Product Change Notice (PCN)

PCN Number: PCN-04022024

- SMM6 series
- SMM12 series
- SMM12-USB series
- SMM30 series

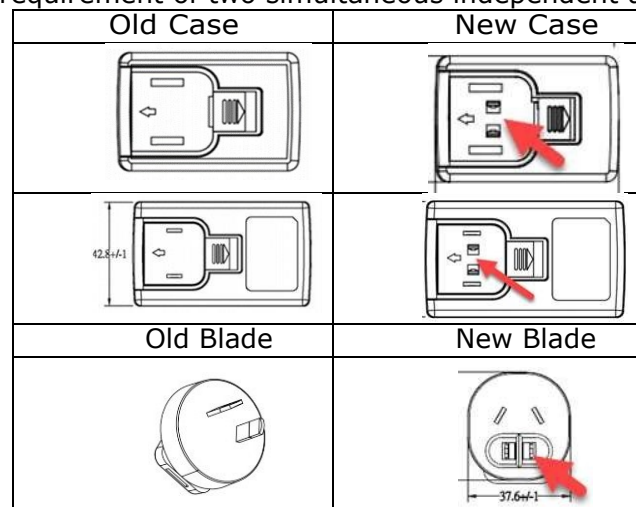
Reason(s) for Change: Per Australia, the update to Appendix J of AS/NZS 3112:2017+A1:2021 requires an adapter case modification and Australia blade retool.

Description of Change: The adapter case modification and Australia blade retool will be compliant to the requirement of two simultaneous independent actions.

Additional Information: The blades in North America, Europe, the UK, and China will remain unchanged, but they will be compatible with and operate with the new case.
